ADDENDUM

ADDENDUM NO.: 04
PROJECT NAME: Salt Dome Replacement Facility (Grand Avenue)
PROJECT NO.: 04021
CONTRACT NO.: C1598
DATE OF ISSUE: January 27, 2021

NOTICE OF CHANGES, MODIFICATIONS, OR CLARIFICATIONS TO CONTRACT DOCUMENTS

Sheet
C1.2A

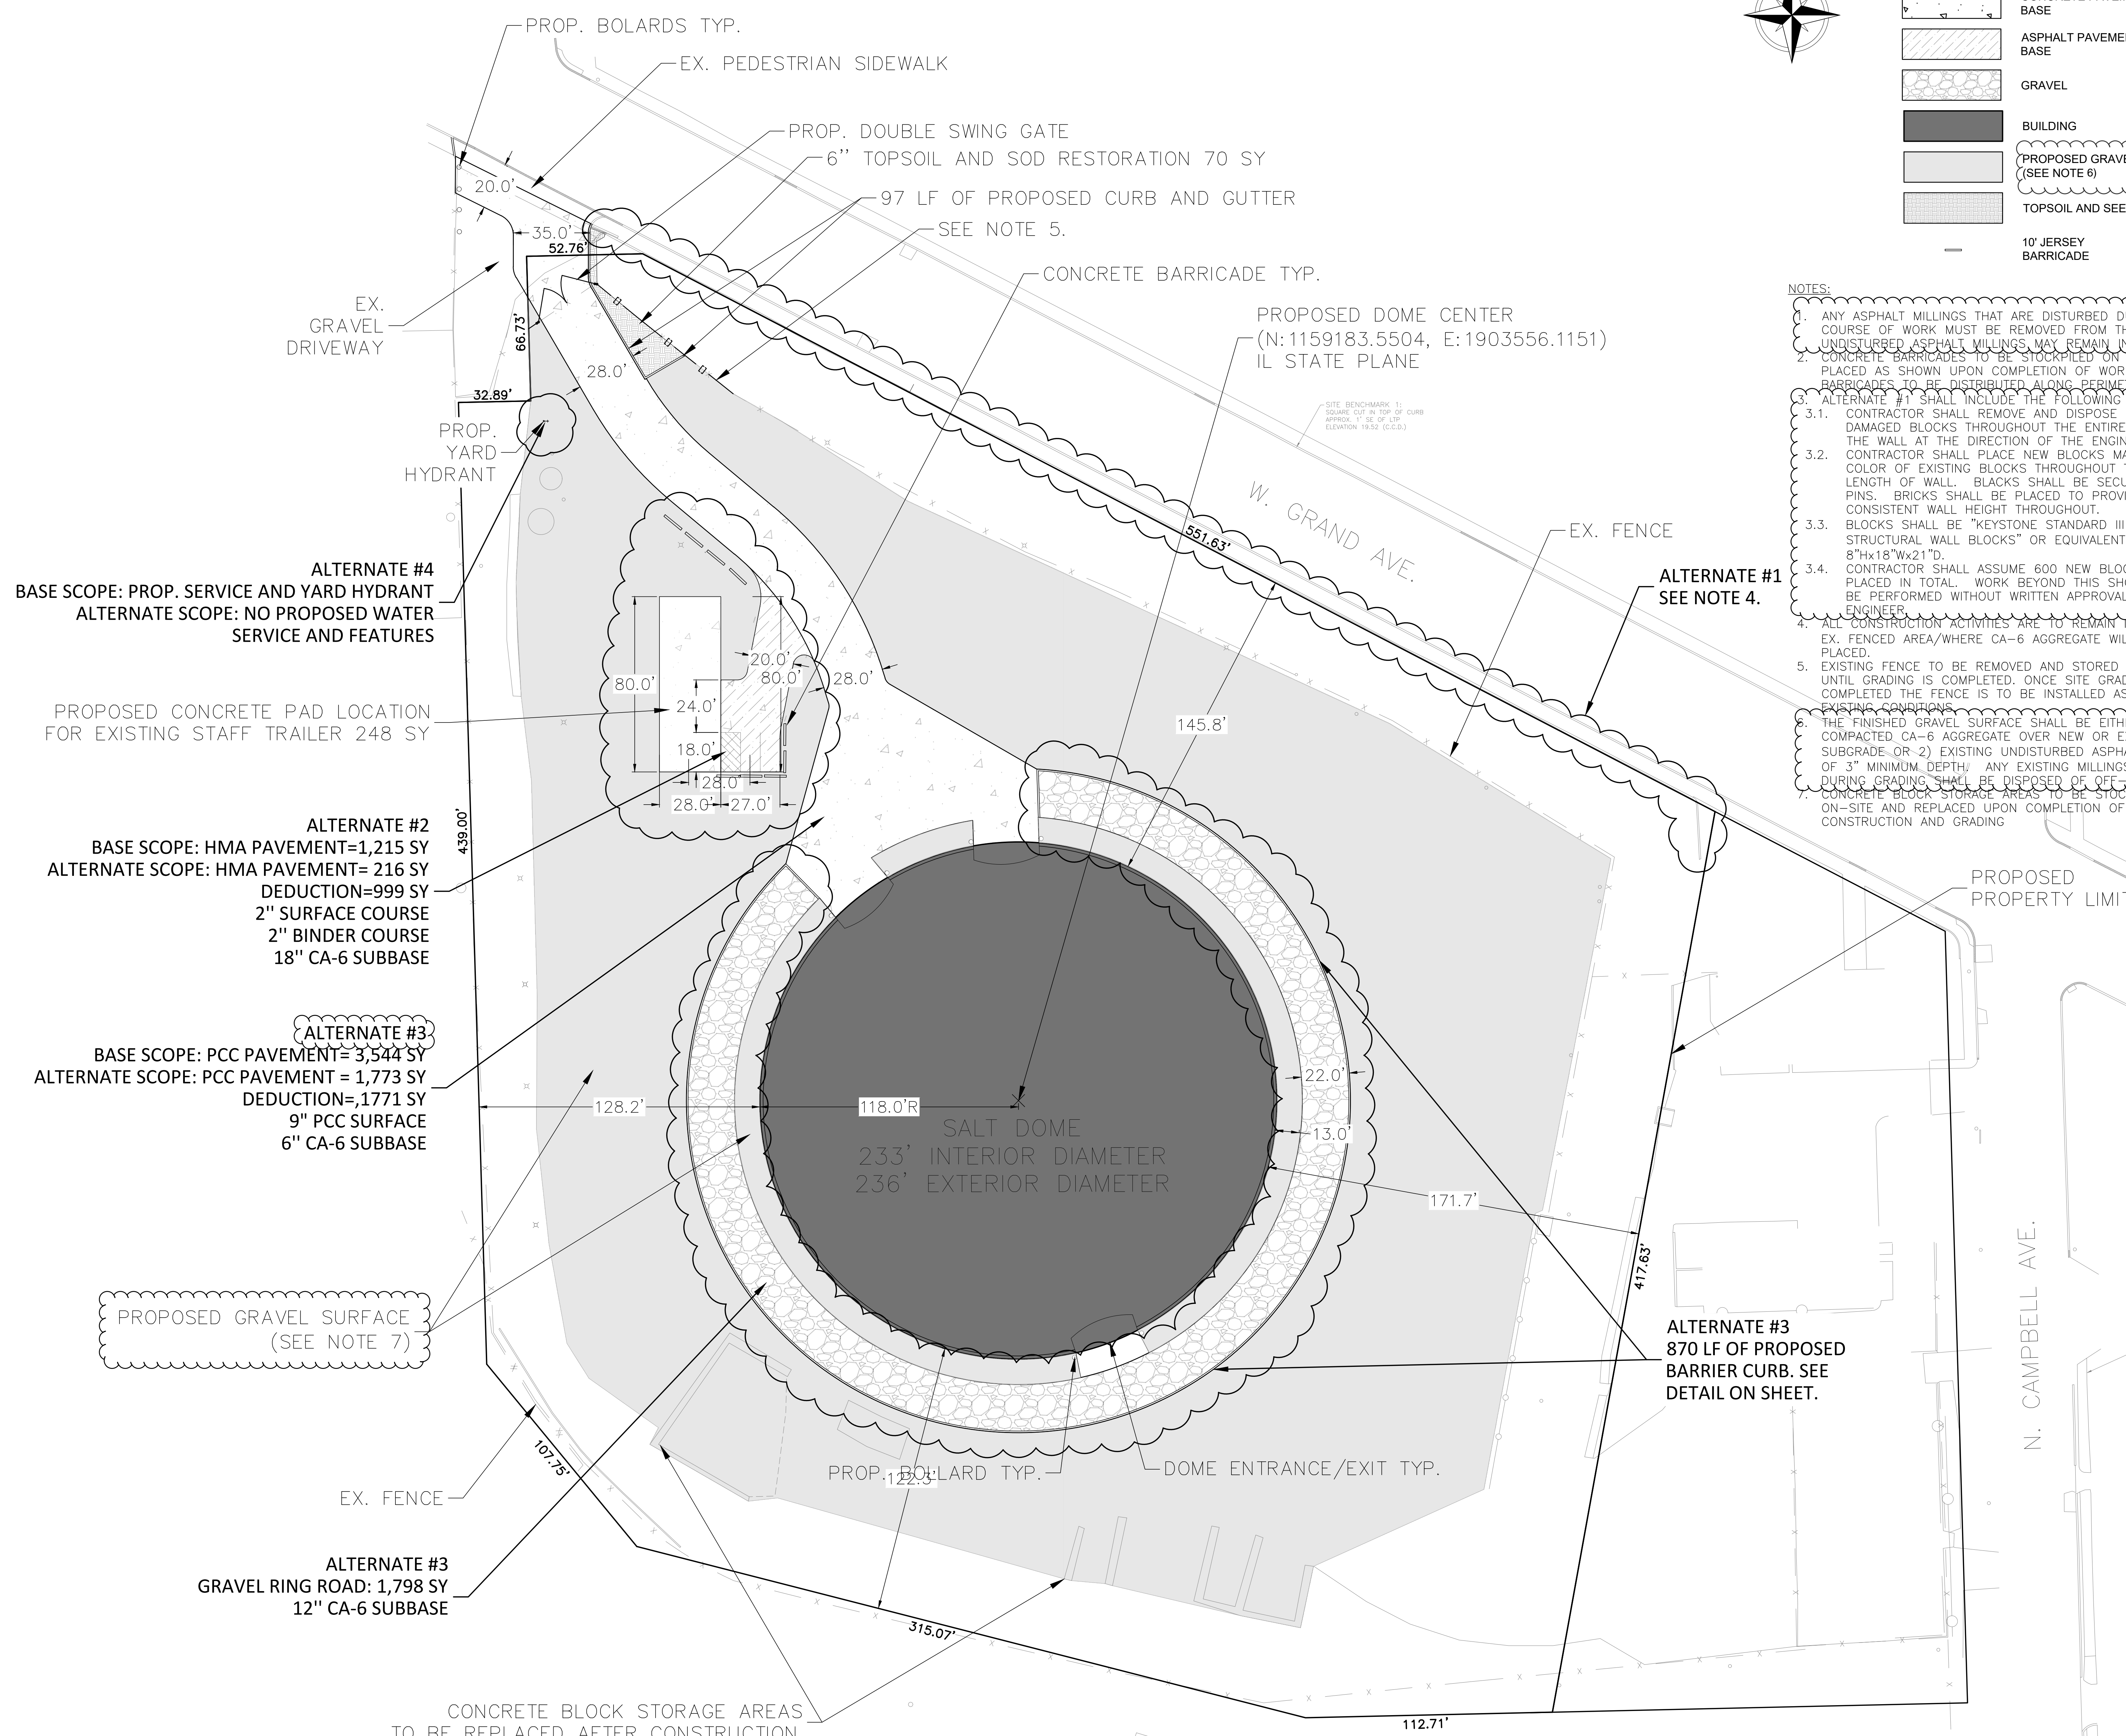
Change 3 **REVISED** Drawing No. C1.2A, Overall Site Plan (Alternates): Updated note 1 to clarify scope of work related to asphalt millings. Updated note 3 to clarify alternate #1 scope of work. Added note 6 and updated legend and callouts to clarify scope of proposed gravel surface.

Question: Bid form lists alternate #1 as reduce existing landscape wall along grand avenue (add). Alternate note #3 on C1.2A indicates for it to be repaired and replaced as needed. Please confirm alternate intent and what scope that should be included in base bid.

Question: Page C1.2 calls out 6" of CA-6 aggregate within the fenced in area. Page C1.2A calls out this same area as existing asphalt milling to be removed per note 1, but does not reference an alternate. Please define the asphalt milling alternate scope.

Question: Sheet C1.2AI appears as if the PCC alternate reduction is part of alternate #2. Please clarify.

Response: Contractors base bid shall not include any work related to the landscape wall. Refer to the revised Drawing sheet C1.2A note #3 for Alternate #1 scope details and included in this Addendum.

Response: Refer to RFI #35 response regarding the CA-6 requirements. Drawing sheet C1.2A has been revised and included in this Addendum to match the base scope of work for the proposed gravel surface.

Response: Drawing Sheet C1.2A has been revised and included in this Addendum. There is no PCC reduction as part of alternate #2. The noted PCC reduction of 1,771 SY should be included as part of alternate #3.

Sheet
E1.1

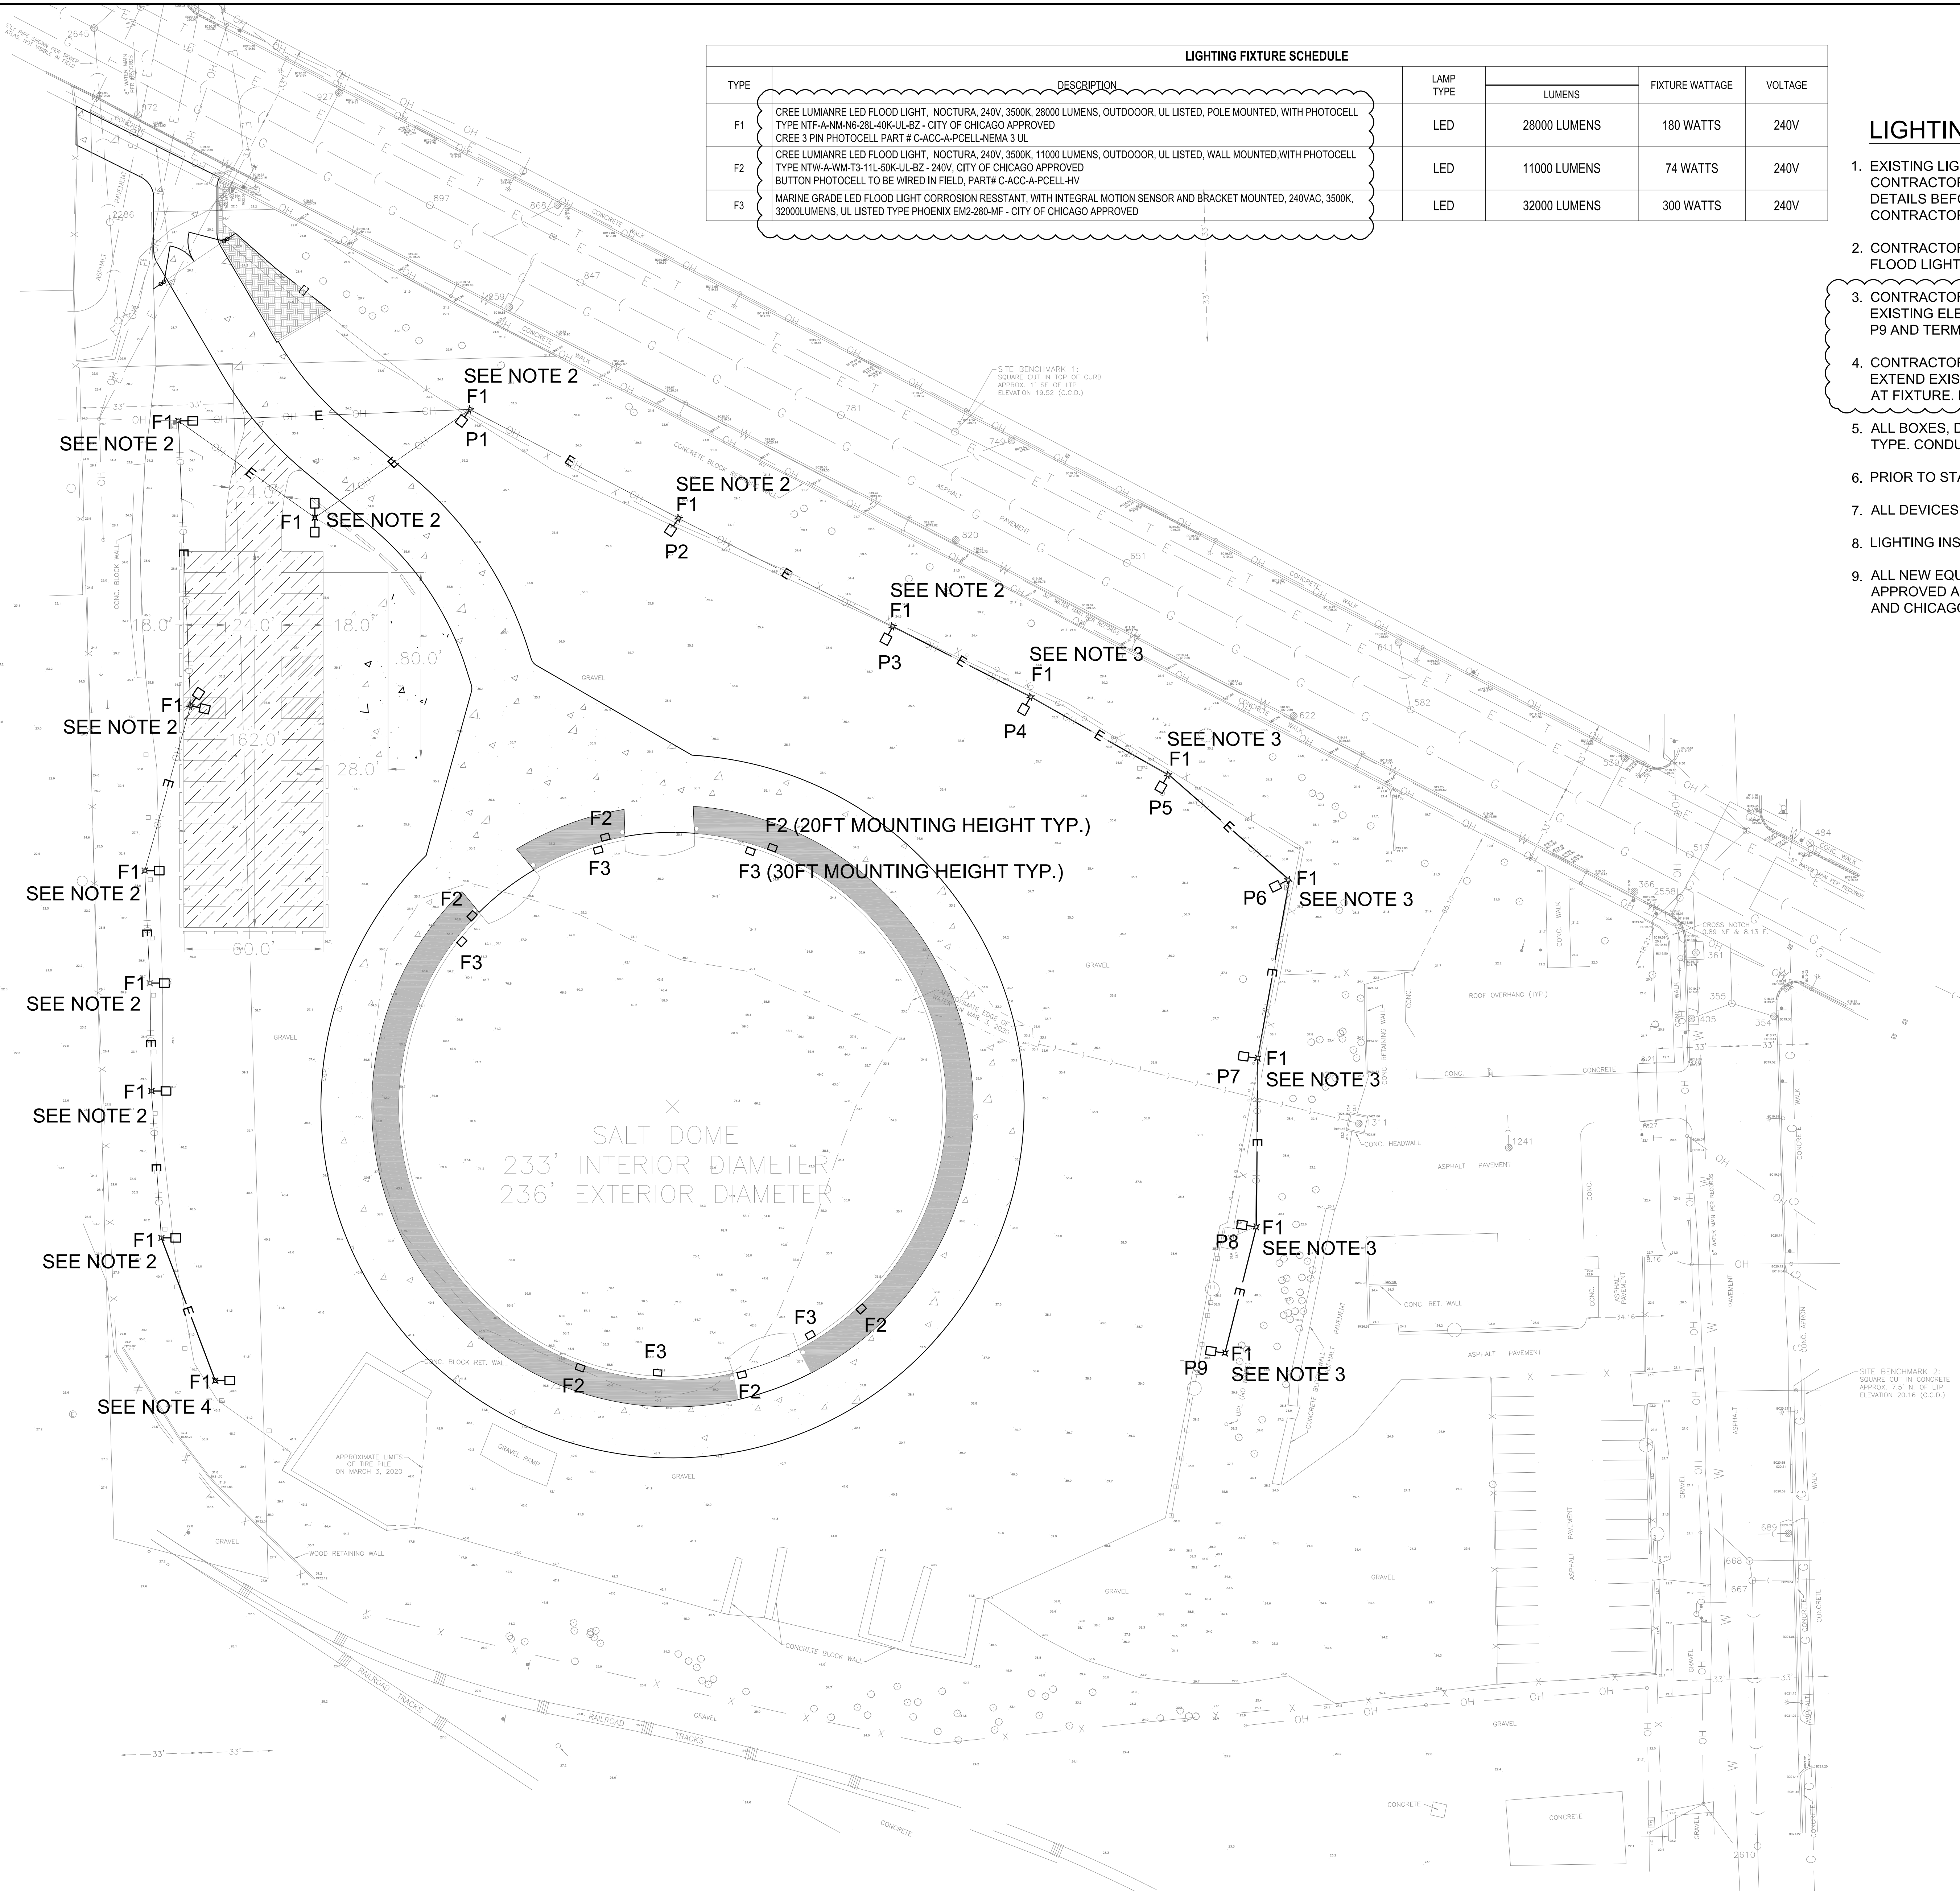
Change 4 **REVISED** Drawing No. E1.1, Site Lighting Plan: Lighting fixture schedule and notes 3 & 4 update for clarity. Sheet scale fixed.

a. Per Drawing E1.1, Note # 4, does this new pole replacement refer to only ONE pole or, is this a “TYP” note for all the pole mounted fixtures? If it is typical, does it contradict Note # 3 on the same page?

Question: (Electrical E1.1) Also, per Notes # 3 & # 4, is the existing areas cable to be re-used to feed new fixture & pole referenced on page, and above (herein)?

Question: Per Note # 6, Drawing E1.1, will the light fixtures come with integral phot-cells or is the contractor responsible for the supply & install of the noted photocells apart from the noted light fixtures?

- Note 4 states to locate the new pole 150' from the last pole however, it measures only 65' away according to the print scale (1" = 30'). Please clarify the correct distance.
- Are the light poles, P1-P9 at the correct scaled distance on the print?

Response: Please refer to Drawing Sheet E1.1 Notes #2, #3, and #4, each only refer to the poles as identified on the plan view callouts. Note #4 refers to only one (1) pole and is not a typical condition.

Response: Drawing Sheet E1.1 has been revised and included in this Addendum. Notes #3 and #4 on E1.1 shall include the following change: "Extend existing electrical aerial cable" shall be revised to "extend existing electrical aerial cable with new electrical aerial cable".

Response: Drawing Sheet E1.1 has been revised and included in this addendum. Please refer to the revised lighting fixture's schedule, the Contractor shall be responsible for procuring and installing the new photocells.

Response: Drawing sheets E1.1 and E1.2 have been revised and included in this addendum. Note #4 on sheet E1.1 to state "CONTRACTOR SHALL INSTALL NEW 45 FT WOOD POLE WITH NEW LED FIXTURE. EXTEND EXISTING ELECTRICAL AERIAL CABLE AND TERMINATE AT FIXTURE. LOCATE NEW POLE APPROXIMATELY 70 FT AWAY FORM THE LAST POLE TO SUIT FIELD CONDITIONS."
